Visual-Manual NHTSA Driver Distraction Guidelines for In-Vehicle Electronic Devices; Notice

[Docket No. NHTSA–2010–0053]

ACTION: Notice of Federal guidelines.

Figure 2: Drawing of Slide Presented by Toyota at NHTSA Technical Workshop¹³⁶

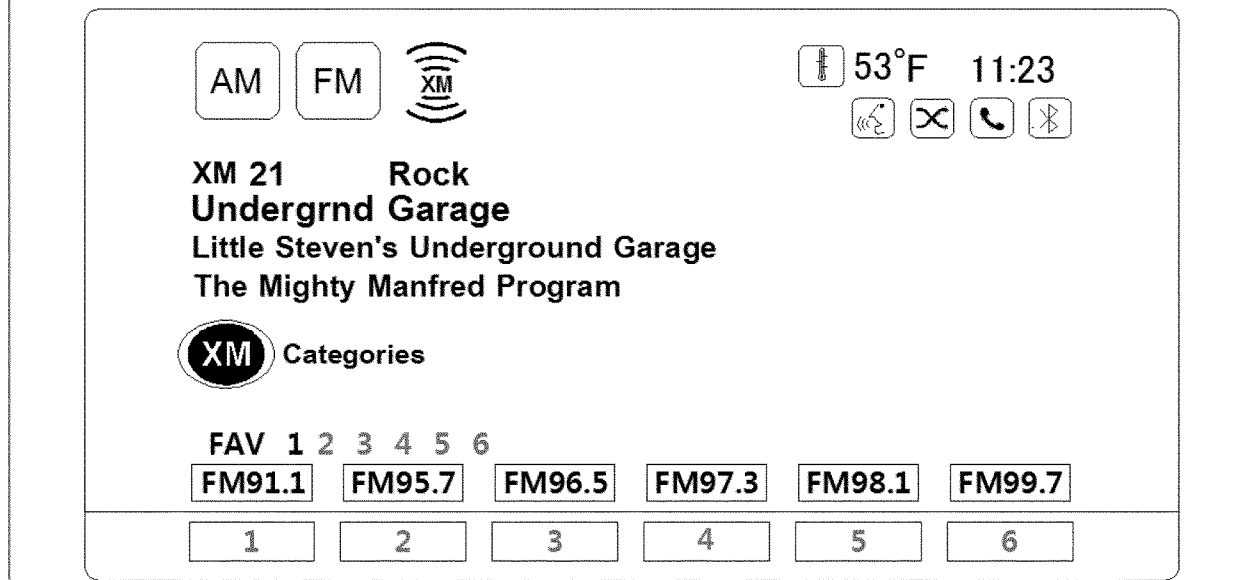
radio station program information (See Figure 2 below). He then asked:

five characters. So once we have the presets presented to the user, we can't give them any other information about what the radio is doing. If you pick any one element within this display, you quickly exceed a 30-character limit * * *¹³⁵

Where should the 30 character limit be applied to this display?

Mr. Foley then pointed out that the information conveyed by this display is easily grasped and that drivers do not have to read each individual letter to understand what is being transmitted by this display.
